[Docket No. FAA-2005-20700; Airspace Docket No. 04-AWA-8]

Establishment of Class C Airspace and Revocation of Class D Airspace, Orlando Sanford International Airport, FL; and Modification of the Orlando International Airport Class B Airspace Area, FL

ACTION: Final rule.

Docket No. 04-AWA-8
ORLANDO, FLORIDA
ESTABLISHMENT OF ORLANDO SANFORD INTERNATIONAL AIRPORT
CLASS C AIRSPACE
 and
MODIFICATION OF ORLANDO INTERNATIONAL AIRPORT CLASS B
AIRSPACE
 (Not to be Used for Navigation)

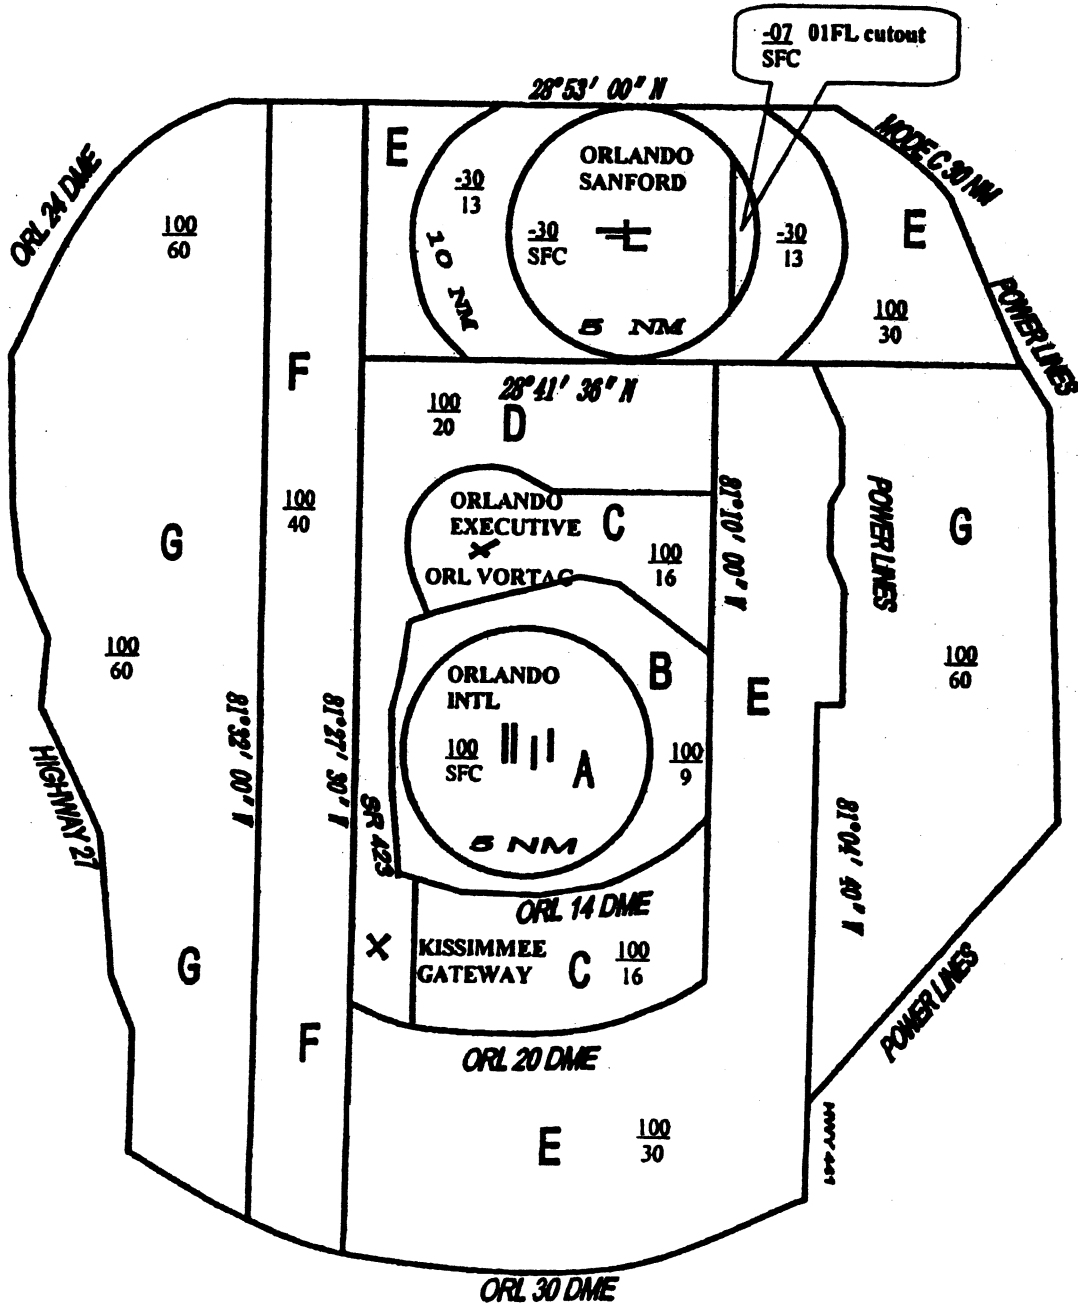
One pilot wrote that the proposed SFB Class C airspace configuration might be unsafe, citing the amount of restricted or otherwise controlled airspace already in the area (R-2910, MCO Class B, Daytona Beach Class C, etc.). The commenter objected to placing Class C airspace around SFB that would extend farther north than the current MCO Class B airspace boundary. This would crowd VFR aircraft into less space, particularly to the northwest of the proposed outer ring where two towers extend to over 1,700 feet MSL.

A suggestion was made that the floor of the SFB Class C airspace in the 5–10 mile ring be raised from 1,300 feet MSL to 1,600 feet MSL to allow transiting VFR aircraft to fly beneath the area at 1,500 feet MSL.

One commenter suggested that a north-south VFR flyway be established directly over SFB.

FAA Response: The commenter is incorrect regarding the extent of the SFB 10-NM ring. The original configuration of the proposed SFB Class C airspace did include a full 10-NM ring north of the airport. However, based on feedback from the ad hoc committee meetings, and as described in the NPRM, the proposed SFB Class C airspace design was changed so that the 10-NM ring was eliminated north of the current northern boundary of the MCO Class B airspace area along latitude 28°53'00" N. Therefore, Class C airspace will not extend into the airspace in question near the towers nor will the SFB Class C airspace result in additional crowding of VFR aircraft between the Daytona Beach Class C airspace area and the current northern edge of the MCO Class B airspace area. Similarly, to the south of SFB, the Class C 10-NM ring was

cutoff along latitude 28°41'36" N. This modification provides additional airspace in the east-west VFR flyway located between Orlando Executive and SFB.

FAA Response: The FAA does not agree with the suggestion. The crossing altitudes at the final approach fixes are 1,500 feet MSL and 1,600 feet MSL. Raising the floor as suggested would result in conflicts that the Class C airspace is designed to eliminate.

FAA Response: The FAA does not agree. Currently, aircraft transitioning over SFB at 1,500 feet MSL, as approved by SFB Tower, total only about five per day. With the implementation of the SFB Class C airspace area, a transition over SFB at 2,500 feet MSL would be possible for aircraft in contact with MCO approach control. A VFR flyway directly over SFB would not be feasible. VFR flyways provide general flight paths for pilots planning flights into, out of, through, or near complex terminal airspace so as to avoid Class B airspace. Flyway altitudes must avoid airspace that requires prior authorization or clearance to enter. A flyway over SFB would result in departures being restricted below the flyway altitude until clear of the flyway. The airspace between 2,000 feet MSL and 3,000 feet MSL over SFB is used to transition arrivals and departures to/from Orlando Executive Airport. Due to the complexity of the airspace in the SFB area, the suggested flyway is not feasible because it would impact SFB operations, and/or require pilots to
